**MEMORANDUM**

**Subject:** Dunwoody Village Master Plan Update

**A RESOLUTION TO AMEND THE CITY OF DUNWOODY VILLAGE MASTER PLAN**

## Chamblee Dunwoody Road Proposed Improvements

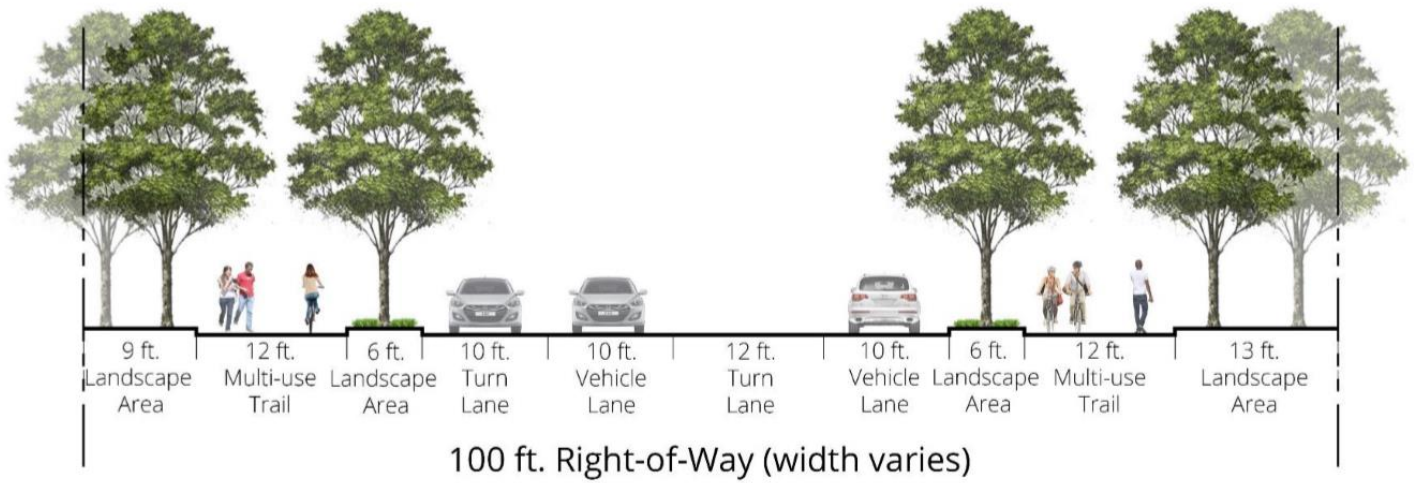
In 2019, the City began to update the zoning regulations for the Village. As a part of this process, street improvements were revisited and updated designs were shared with the community at a public workshop on June 29th, 2019. The updated improvements are now shown in graphic (rather than narrative) form. They now include designs for the road area between the curb, in addition to sidewalk and landscaping improvements, in order to include the full width of the right-of-way and show lane widths. The width of sidewalks and landscape areas have been clarified (they were described as ranges in the previous plan).

The goal of these proposed changes is to provide clarity, ensure adequate and safe spaces for pedestrians and bicyclists, and slow traffic to be consistent with the character of an urban village. The updated designs are aspirational and will need to remain flexible as funding is available to implement them, given the varying width of rights-of-way, unique conditions at intersections, and other site conditions. The following street sections are recommended to replace those in the 2011 Master Plan.

Staff recommends approval of updates to the Dunwoody Village Master Plan with Exhibits A and B replacing the street designs in the 2011 Master Plan.
